GRE TF S/R – 17th meeting

Agenda item: 7.1 H11 category sheet changes

Walter Schlager, Philipp Plathner – IEC

Existing H11 (LEDr) category sheet (WP.29/2021/145)

Figure 1
Main drawings

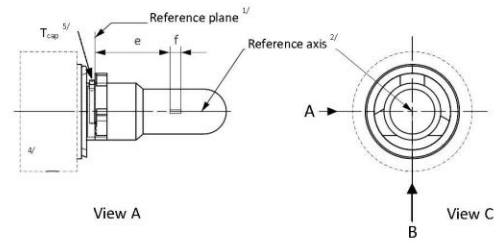
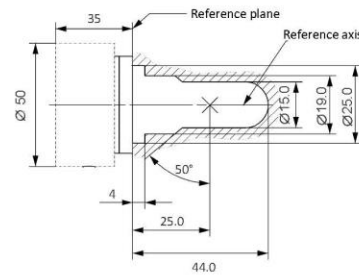
Keep “Sheet H11_LED/1”

- Main drawing
- Maximum outline

Figure 4

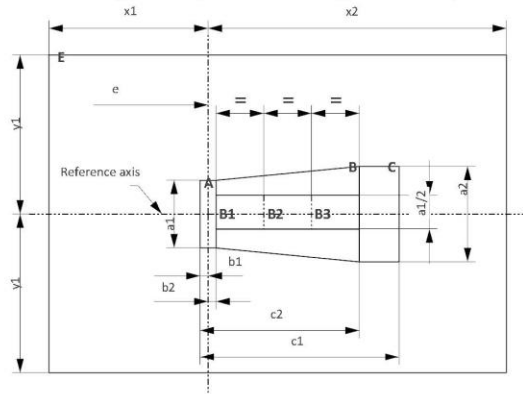
Modify "Sheet H11_LED/3"

- Keep box check from view A and -A (main emission directions)
- Keep the contrast requirement
- This will ensure same glare level !

- Take out the box check from view B (secondary emission direction)
- ... and replace it by a maximum extension ("thickness")
- This will ensure beam control !

In case of Embodiment 1 the position of the light emitting area is checked by a box system defined in Figure 4 when operated at test voltage, which shows the projections when viewing from B (see sheet H11 LEDr/1, Figure 1) and from A and -A (see sheet H11 LEDr/1, Figure 1), i.e. along the C-planes C_0 , C_{90} and C_{270} (as defined in Figure 6).

In case of Embodiment 2 the position of the light emitting area is checked by a box system defined in Figure 4 when operated at test voltage, which shows the projections when viewing from A and -A (see sheet H11 LEDr/1, Figure 1), i.e. along the C-planes C_{90} and C_{270} (as defined in Figure 6). The distance z between the surface of the two light emitting areas when viewing from B (see sheet H11 LEDr/1, Figure 1) shall not exceed [2.9 mm].

In both configurations, the proportion of the total luminous flux emitted into these viewing directions from the area(s) as defined in Figure 4:

FULL PHOTOMETRIC EQUIVALENCE

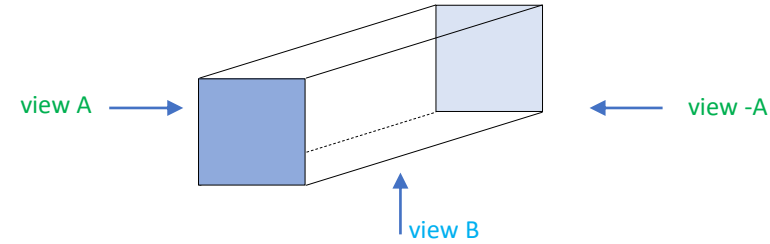
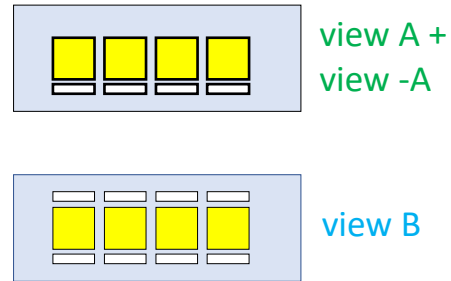
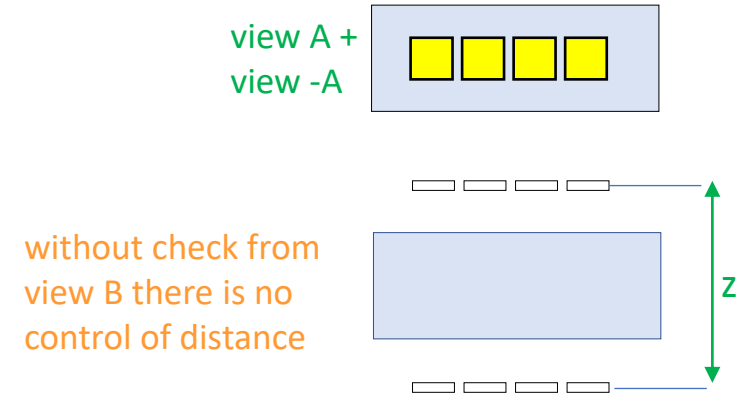
➔ Need to limit the maximum extension "z"!

Figure 5
Box definition of the area D (dimensions given in Table 2)

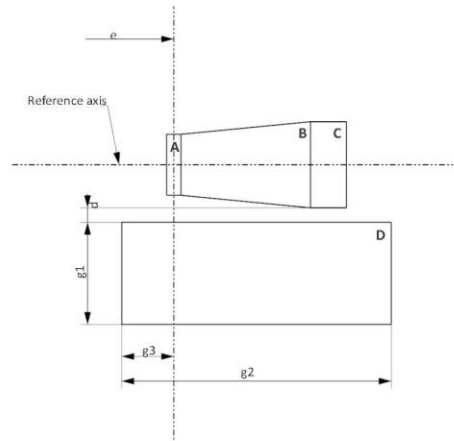
Keep “Sheet H11_LED/4”
- Including box dimensions

Figure 6

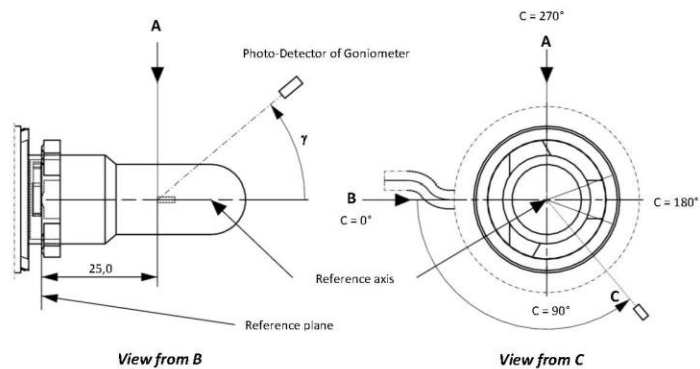
Keep "Sheet H11_LED/5"

- Including test set-up
